TO:	Susan Pelz Florida Department of Environmental Protection – Southwest District Office 13051 North Telecom Parkway Temple Terrace, Florida 33637	DATE	March 31, 2010
		JOB. NO.	08449-030-04 Task 2100
		RE:	Southeast County Landfill Minor Permit Modification Application - Leachate Management Plan Updates – Response to FDEP Request for Additional Information

**LEACHATE MANAGEMENT PLAN UPDATES  
RESPONSE TO FDEP REQUEST  
FOR ADDITIONAL INFORMATION  
PHASES I-VI AND THE  
CAPACITY EXPANSION AREA  
(SECTIONS 7, 8, AND 9)  
SOUTHEAST COUNTY LANDFILL  
HILLSBOROUGH COUNTY, FLORIDA**

RE: Hillsborough County Southeast County Landfill  
Leachate Management Plan, Phases I-VI and Sections 7, 8 and 9  
Pending Permit Modification No. 35435-017-SO/MM to Permit No. 35435-014-SO/01  
Jones Edmunds Project No.: 08449-030-04 Task 2100

This letter addresses comments received from the Florida Department of Environmental Protection dated **February 25, 2010**. Each of the Department's comments is presented below in *italics*, followed by the response in **bold** type.

ATTACHMENT 2  
CONTAINMENT AREA DRAWINGS

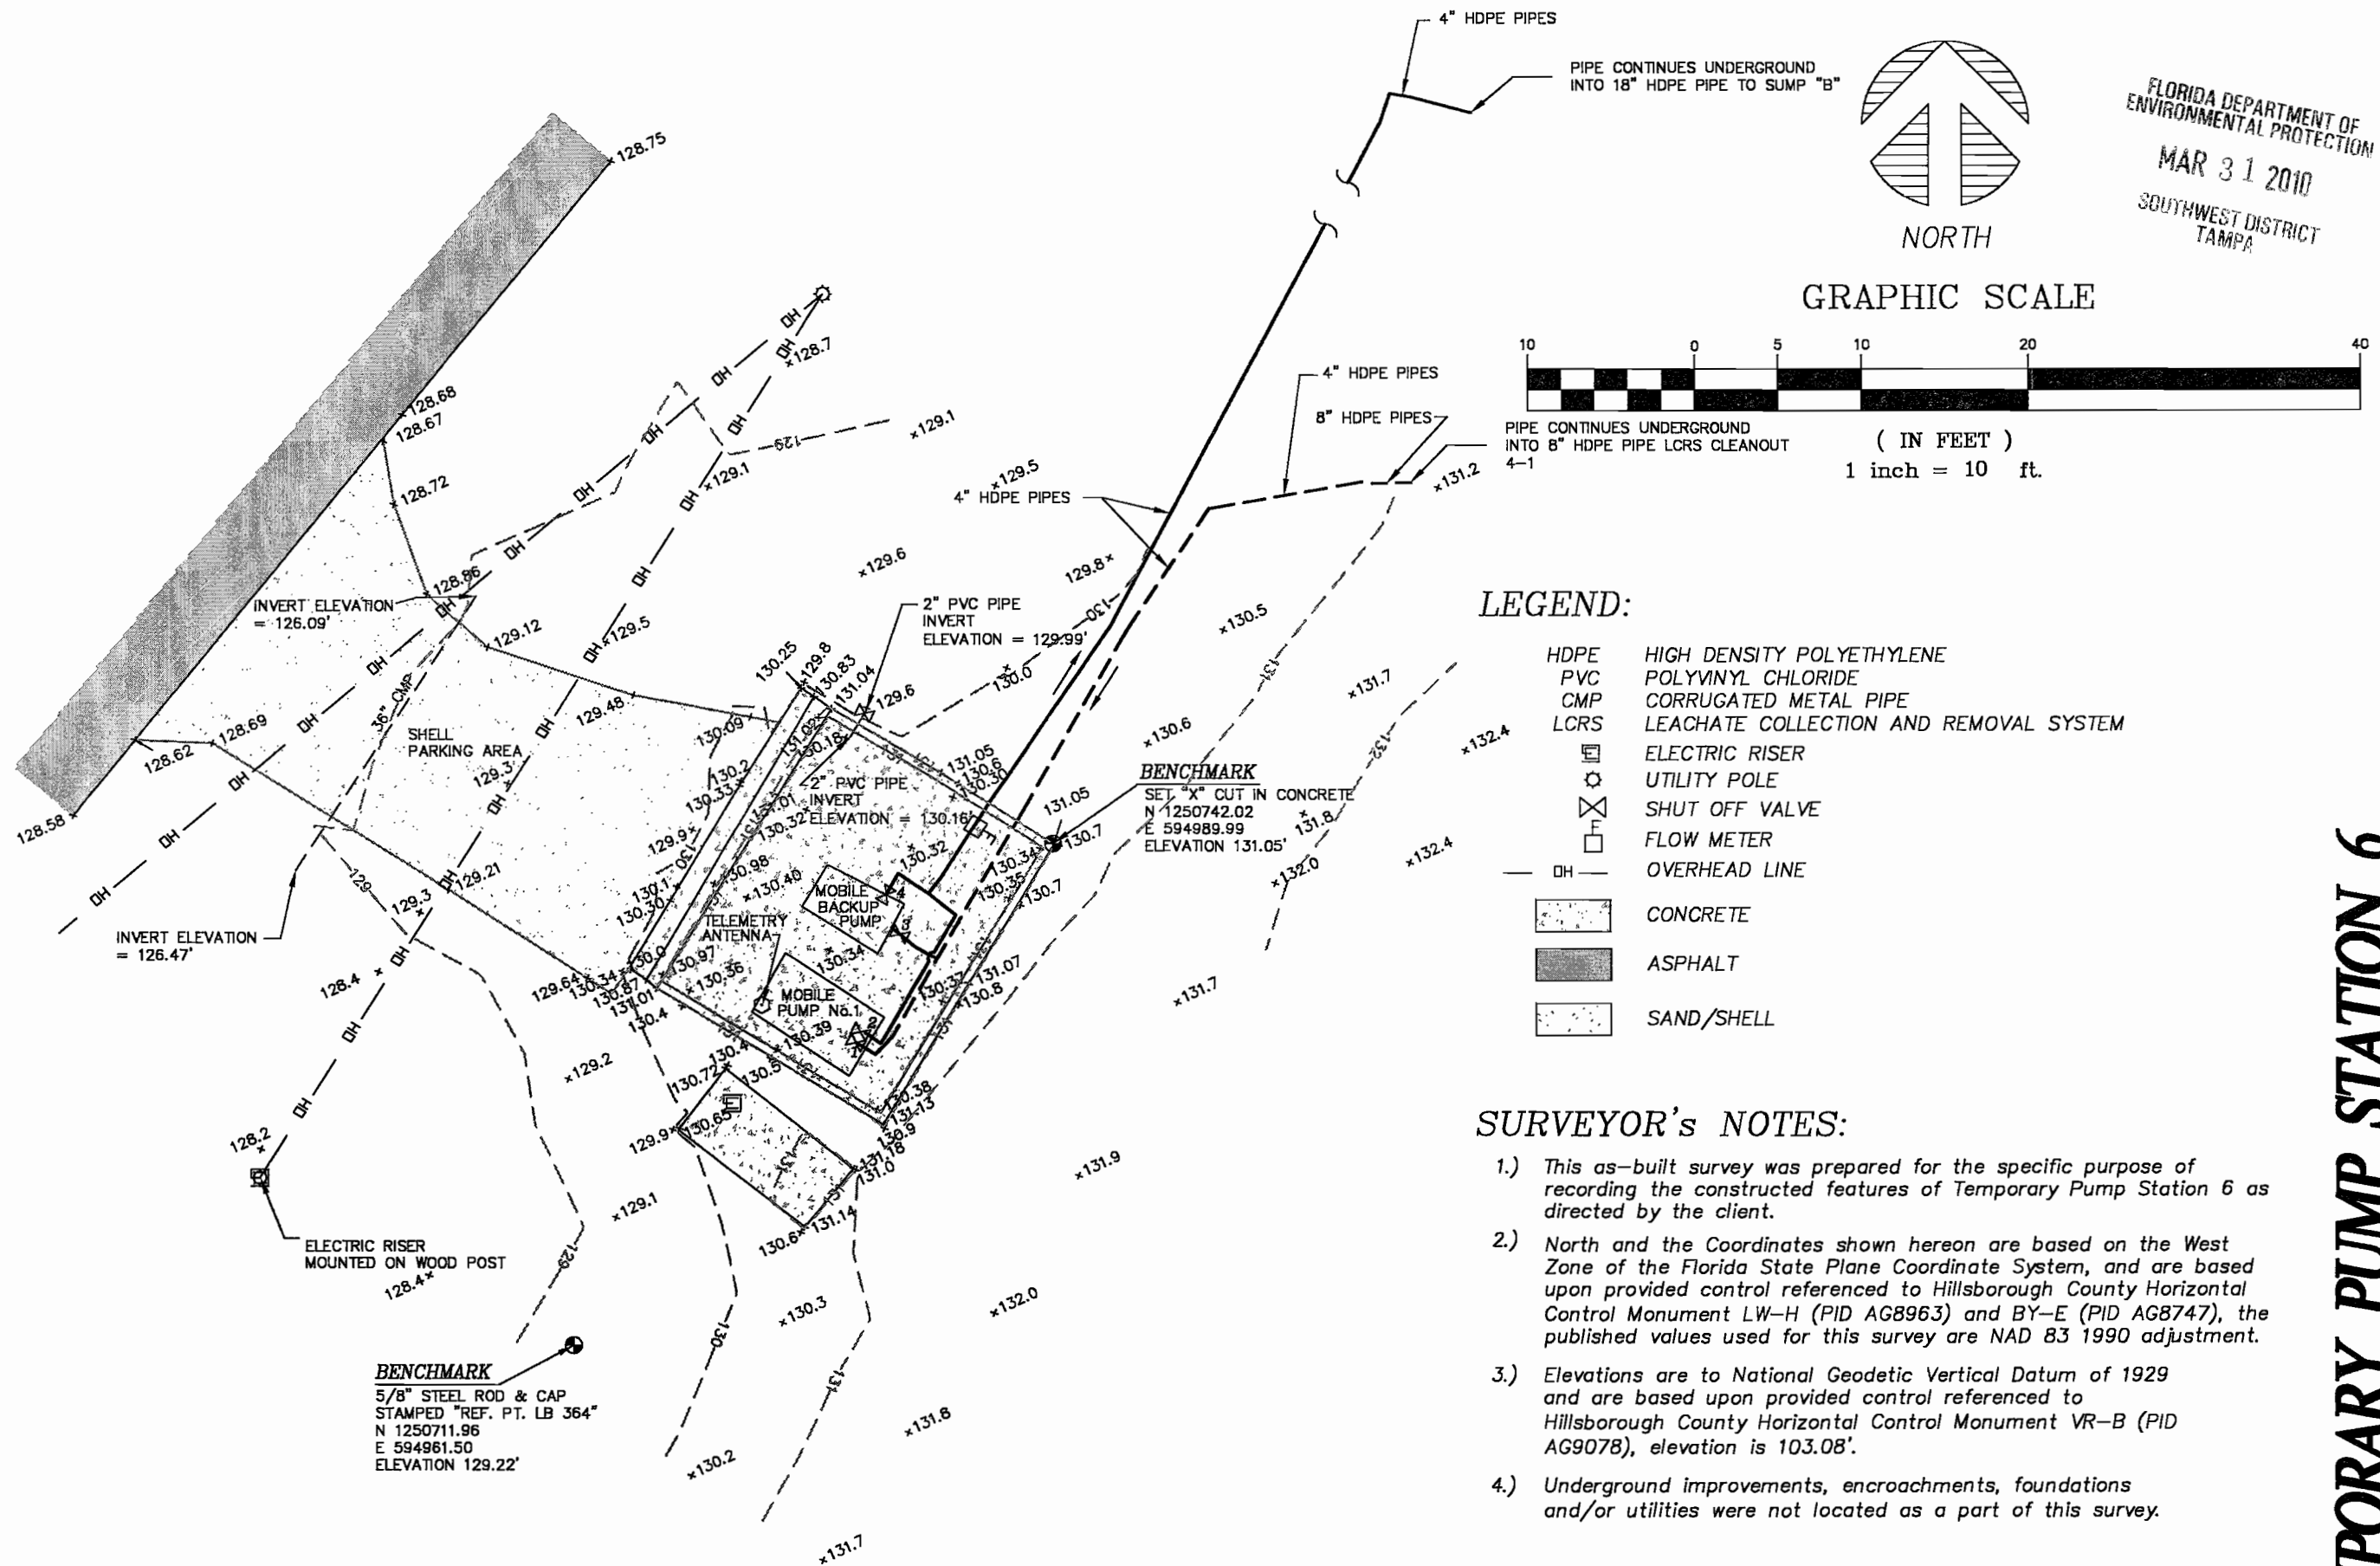
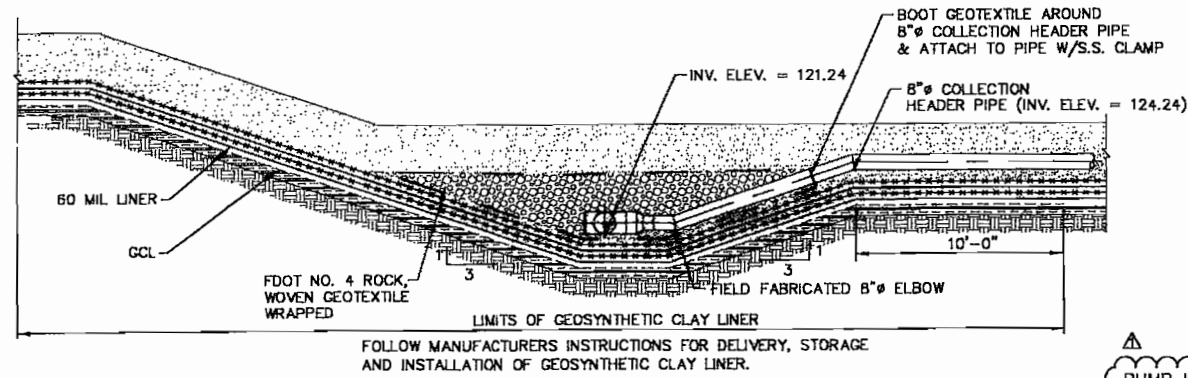
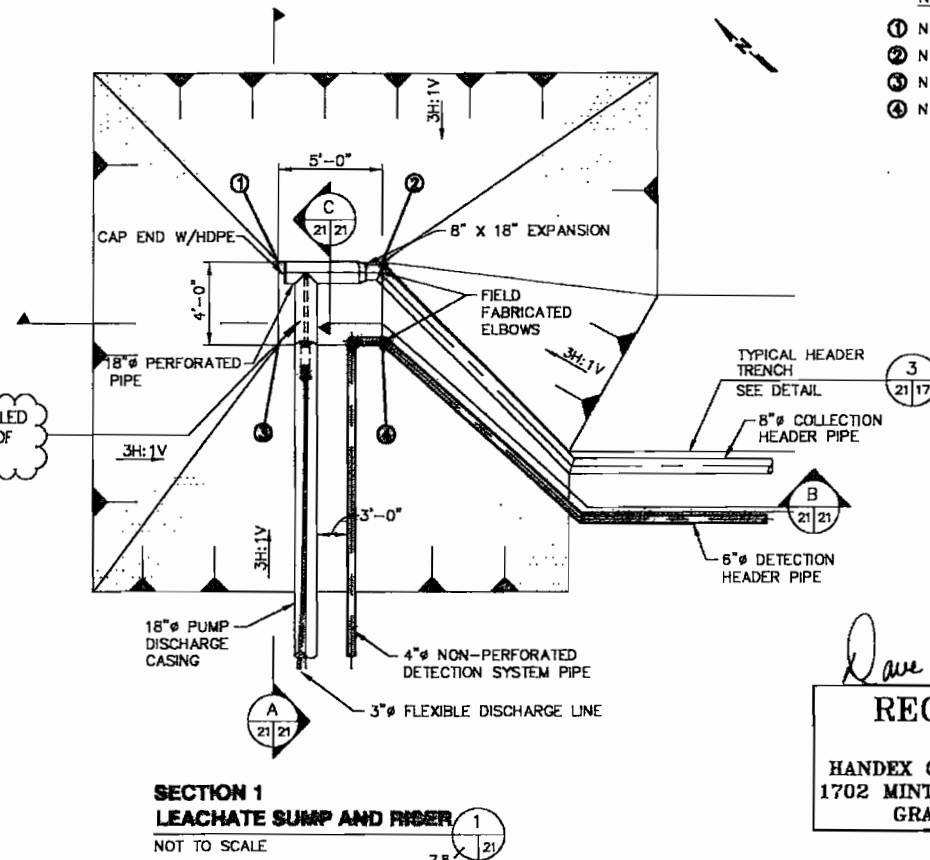
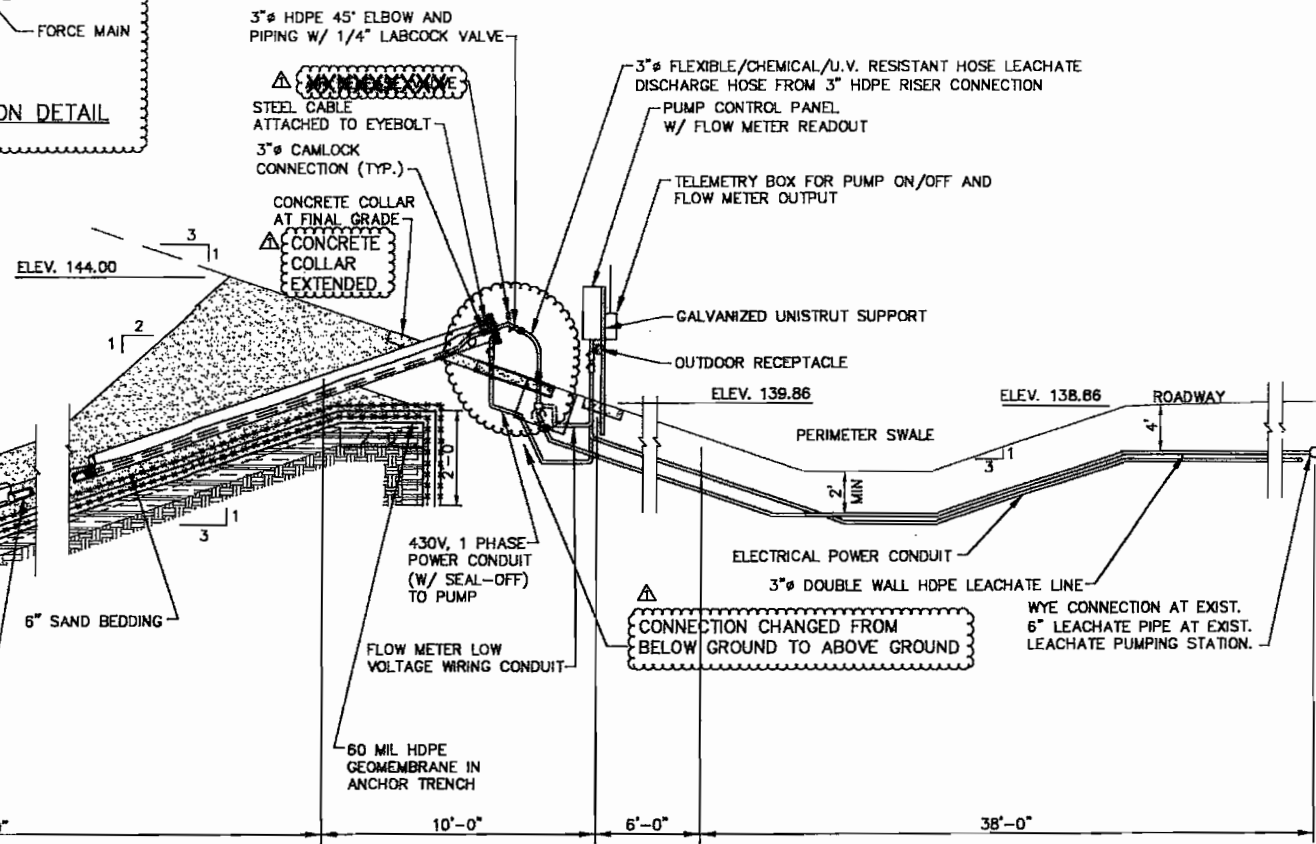
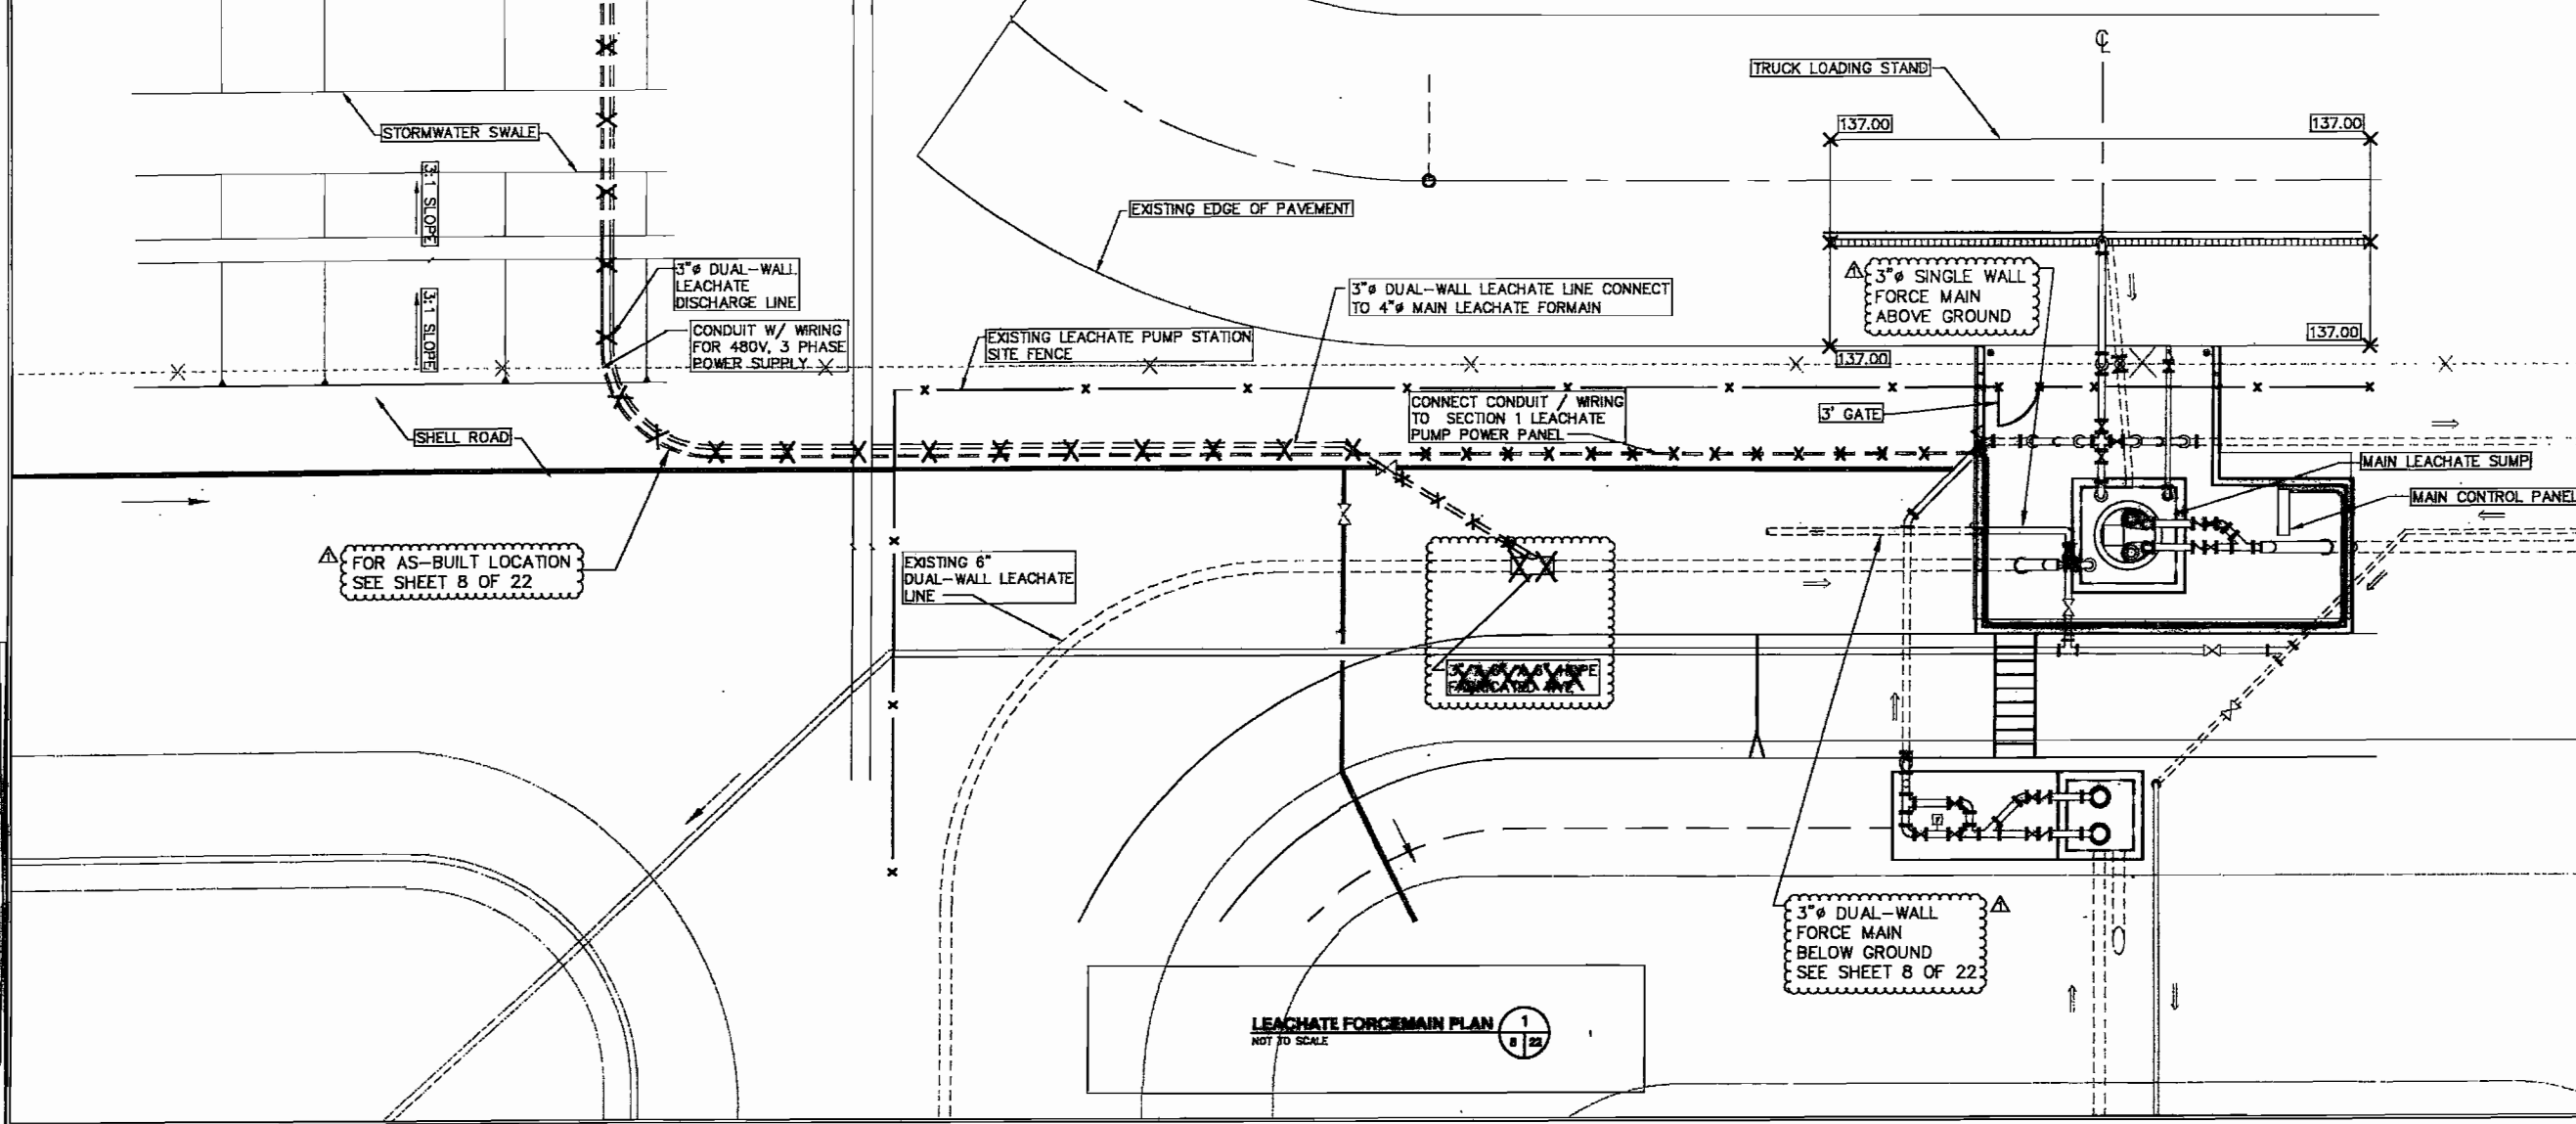
*Comment 3: Section 4.0. Please include containment structure details for each of the pump stations described in this section.*

**Response 3:** The containment structure as-built drawings for each pump station are provided in separate documents from the LMP included as part of record drawings and construction completion correspondence. For the Department's convenience, the as-built drawings for the containment structures at Pump Station A/B, Section 7, Section 9, the Main Leachate Pump Station (MLPS), and the Temporary Pump Station 6 are provided in Attachment 2, but have not been included in the LMP because the details are not necessary for operation.
